Truck			Bus			Power Solutions			
4	PGRT	LPGRS	4	FKN	CK	P93	P96	E2011	PS2024
-	-	X	-	-	X	-	-	-	-

## Assembly tool 3 151 712 missing screw for working with preload of differential bearings

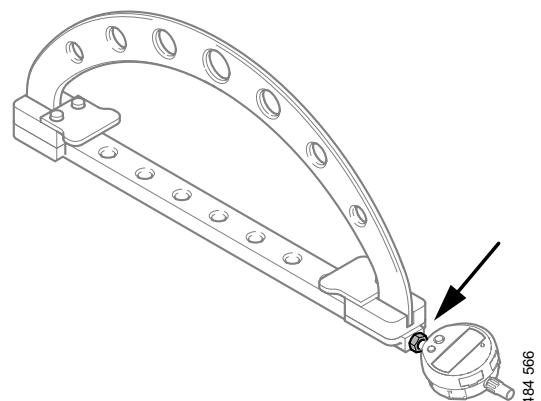
*Assembly tool gauge 3 151 712* – missing a screw to attach *Gauge 3 166 409*.

Order the screw locally to solve the problem until *Assembly tool gauge 3 151 712* is updated with a screw inserted on the Scania number.

Supplier: Ravema AB Hoffman Group, supplier part number: 434825-8 (5 items included).

1. Place 434825-8 between 3 151 712 and 3 166 409 to attach the dial gauge.
